AMENDMENT OF SOLICITATION / MODIFICATION OF CONTRACT			1. Contract Number	Page of Pages 1 2
2. Amendment/Modification Number DCKT-2011-B-0016-0004	3. Effective Date See 16C Below	4. Requisition/Purchase Request No.	5. Solicitation Caption Build-Out of Tire Shop

**BUILD OUT OF TIRE SHOP AND ADMINISTRATIVE OFFICES
SOLICITATION DCKT-2011-B-0016 MODIFICATION NO. 0004
ATTACHMENT A – LOCKER SPECIFICATION**

**BUILD OUT OF TIRE SHOP AND ADMINISTRATIVE OFFICES
SOLICITATION DCKT-2011-B-0016 MODIFICATION NO. 0004
ATTACHMENT B – REVISED SPECIFICATIONS/DETAILS**

EXISTING PARAPET DETAIL

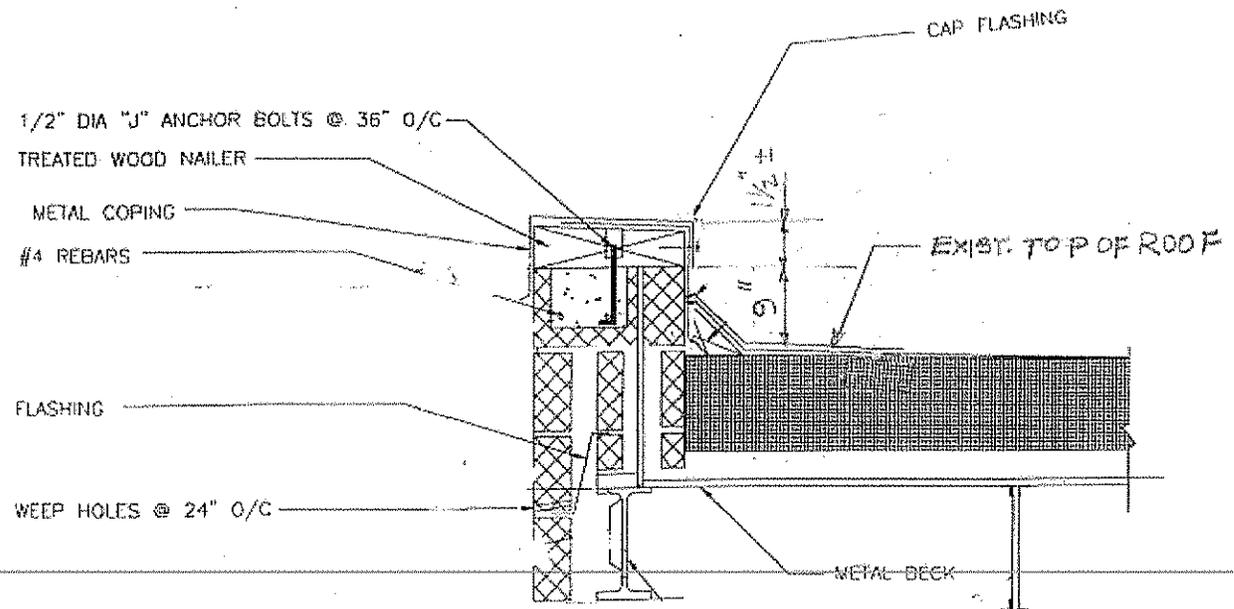
Contractor to verify existing condition of parapet, and if different to notify engineer as soon as possible.
